Access Compliance Report

Public Rights-of-Way

(Curb Ramps)

Intersection ID: 13891	Main Street: CLEMENT_AV	Cross Street: E_7TH_ST	Location: W
ADA ID: C21E34103A96	Ramp Type: Perp	Initial Pass/Fail: Fail	Overall Compliance: No
			Severity Score: 13.75

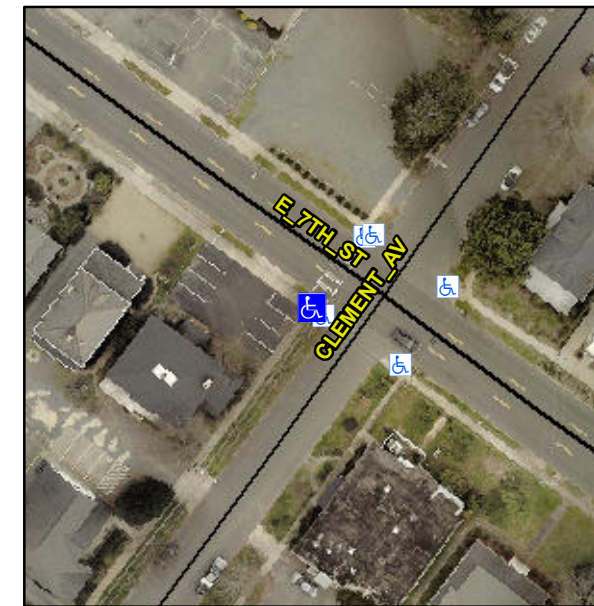
R304.2.2, R304.5.3

Compliance	Description	Data	Compliance	Description	Data
N/A	Ramp Length (in)	55.0	No	Ramp Slope (%)	8.8
Yes	Ramp Width (in)	55.0	No	Ramp XSlope (%)	4.8
N/A	Flare Type LT	N/A	N/A	Flare Type RT	N/A
N/A	Flare Slope LT (%)	N/A	N/A	Flare Slope RT (%)	N/A
N/A	Flare Traversable LT?	N/A	N/A	Flare Traversable RT?	N/A
N/A	Landing Length (in)	N/A	N/A	DWS Provided?	N/A
N/A	Landing Width (in)	N/A	N/A	DWS Contrast?	N/A
N/A	Landing Slope (%)	N/A	N/A	DWS Length (in)	N/A
N/A	Landing X Slope (%)	N/A	N/A	DWS Full Width?	N/A
N/A	Landing Curb? (Y/N)	N/A	N/A	DWS Offset (in)	N/A
N/A	Shared Landing?	N/A			
N/A	Gutter Ponding?	N/A	N/A	Gutter Slope (%)	N/A
N/A	Gutter Lip Ht (in)	N/A	N/A	Gutter X Slope (%)	N/A
N/A	Painted X Walk1?	Yes	N/A	Painted X Walk2?	N/A
	X Walk 1 Direction	To NE		X Walk 2 Direction	N/A
N/A	X Walk 1 Width (in)	111.0	N/A	X Walk 2 Width (in)	N/A
	X Walk 1 Slope (%)	2.6		X Walk 2 Slope (%)	N/A
	X Walk 1 X Slope (%)	3.6		X Walk 2 X Slope (%)	N/A

Remove & Replace Entire Ramp.
